SUBJECT/OBJET LOCAL OFFICIAL PLAN AMENDMENT 9

CITY OF NEPEAN (MONARCH DEVELOPMENT CORP.)

APPROVAL PAGE AMENDMENT NO. 9 TO THE OFFICIAL PLAN OF THE CITY OF NEPEAN

Schedule A4 is the Land Use Plan for the Jockvale Golf Course Community (District 12A). Its components are:

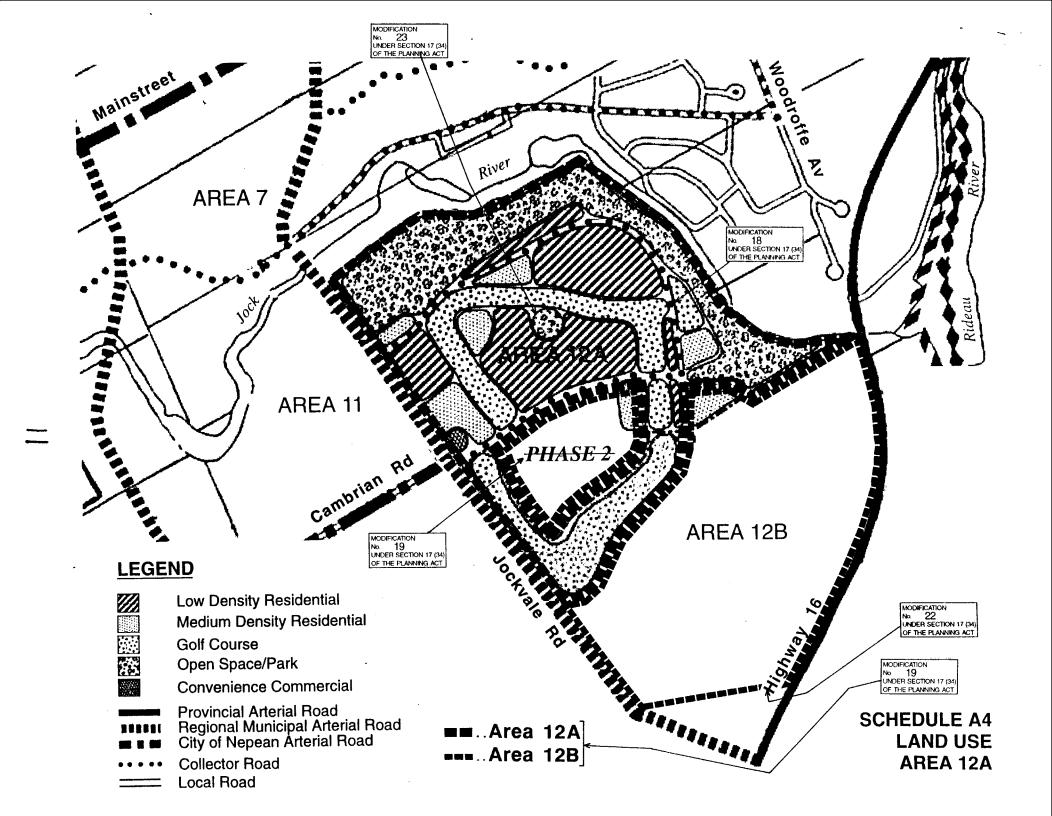
SCHEDULE A4, LAND USE, AREA 12A, be modified by moving the "Collector Road" symbol from the eastern portion of the property to a more central location as identified on SCHEDULE A4.

SCHEDULE A4, LAND USE, AREA 12A, be modified by deleting reference to "Phase 2", introducing a symbol and boundary for Area 12A and Area 12B.

SCHEDULE A4, LAND USE, AREA 12A and SCHEDULE B4, RESIDENTIAL UNIT TARGET, AREA 12A, be modified to delete reference to "Highway 16" and replace it with "Regional Road 73 (former Highway 16)".

SCHEDULE A4, LAND USE, AREA 12A, be modified to move the "Open Space/Park" designation in the centre of Area 12A from the north edge of the surrounding "Low Density Residential" designation to the south edge of the same designation and redesignate the lands on which the "Open Space/Park" designation was previously on "Low Density Residential".

SCHEDULE A4, LAND USE, AREA 12A, be modified to move redesignate the "Low Density Residential" parcel of land at the northeast corner of the northernmost intersection of Jockvale Road and the proposed collector "Medium Density Residential".

Modification No. 18 is proposed to optimise transit routing through Area 12A by minimising the length of road buses would need to travel in order to serve the population.

Modification No. 19 is proposed to introduce a graphic distinction between Areas 12A and 12B and delete reference to "Phase 2" as it is not relevant to the partial approval of LOPA 9.

Modification Nos. 23 and 24 are proposed to implement changes to the land use designations requested by the developer that Nepean staff concur with.

Figure 5 shows the servicing system and stormwater management facilities planned.

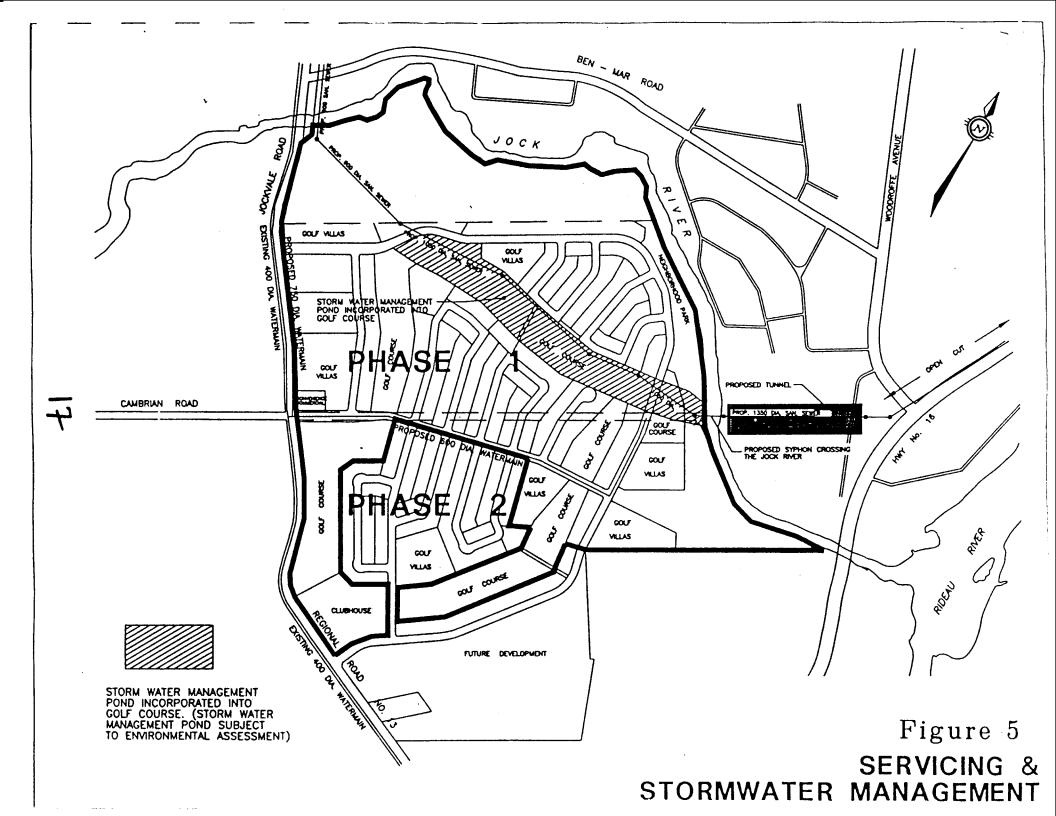
MODIFICATION No. 1 UNDER SECTION 17 (34) OF THE PLANNING ACT Figure 5 shows a stormwater management pond system incorporated into the design of the golf course. Concurrent with the approval of the Secondary Plan for District 12A an environmental assessment for the stormwater management solutions will be undertaken. This environmental assessment would have to address which of the three above-mentioned scenarios would be appropriate for the development. The proposed concept can incorporate any of the proposed stormwater management scenarios. It would also have to finalize the pond configurations and determine whether wetlands, wet ponds, or some alternate type of stormwater management would be required to service these lands.
